Access Compliance Report Public Rights-of-Way (Curb Ramps)

Main Street: ANTONIO_PKWY Cross Street: CORPORATE_DR Location: NE

ADA ID: RPRK211115165900 Ramp Type: Type 1 - Perpendicular Diagonal Initial Pass/Fail: Fail Overall Compliance: No Severity Score: 15

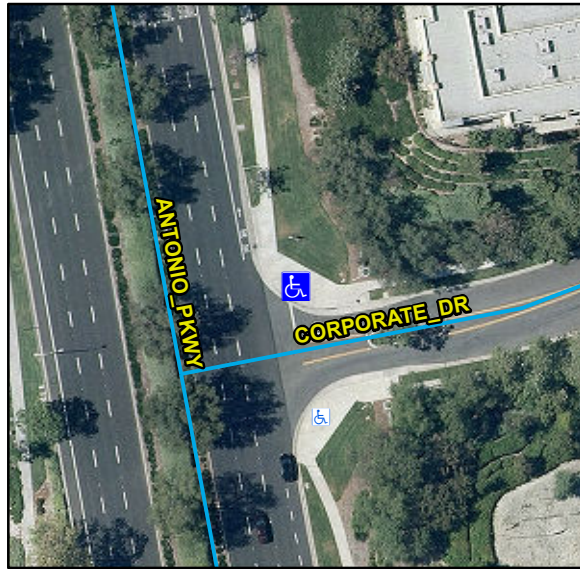
R304.2.2, R204.3, STD 1115

Remove & Replace Curb Ramp With Two New Directional Ramps or Equivalent.
